CA IOU Response to 15-day language_Air Filter Labeling

Response to 15-day Language for
Air Filter Labeling

Docket # 15-AAER-1

May 8th, 2015

Figure 1 - Filter size survey data

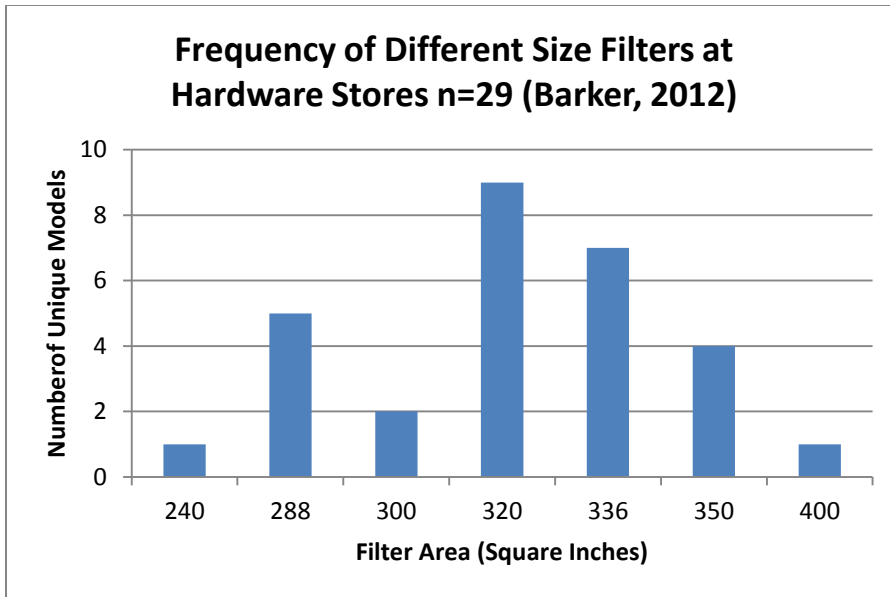
It is the belief of the IOUs that this language is to allow for filter performance benchmarking, while not requiring testing of every different sized model of filter. Rather than providing nominal descriptions of the sizes, the CEC should specify exact filter sizes to ensure consistent benchmarking between different filter manufacturers.

Figure 1, below, shows the results of a survey conducted in 2012 which identifies the relative frequency of different filter sizes by unique model. Based on this data, the IOUs recommend that the CEC specify that filters be tested in sizes of 288 in², 320 in², and 350 in².
